ADDENDUM NO. 1

PROJECT NAME: Animal Science Solar Roof
UNL PROJECT NUMBER: A102P025

CONSULTANT: Architectural Design Associates, PC
7501 O Street, Suite 105
Lincoln, NE 68510

DATE OF ISSUANCE: July 20, 2012
DATE OF BID OPENING: July 31, 2012

Seamer Rental Request Form

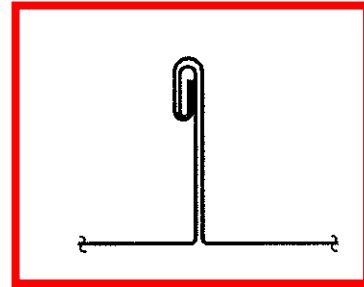
1. At page 5, under section 2.03, paragraph 4 'Clamps', add the following note e:
"e. The standing seam roof supplier is ATAS. The Clamps must accommodate the ATAS Field-Lok System 2" seam with double 180 degree bent seams. See attached ATAS "Seamer Rental Request Form."
